## Service Bulletin

**Bulletin No:** JC-13-19

**Product Type:** Predator, Predator Pro & ProCat G series

**Customer Issue:** Hydraulic oil leaking on top of the oil tank

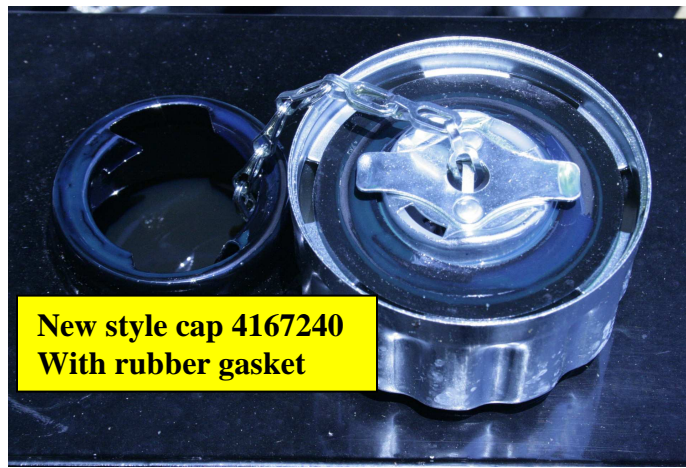
**Cause:** Cap with Cork gasket will deteriorate over time, preventing a good seal.

**Action Required:** Replace old style oil tank cap (4165236) with new style cap (**4167240**) that has a rubber seal.
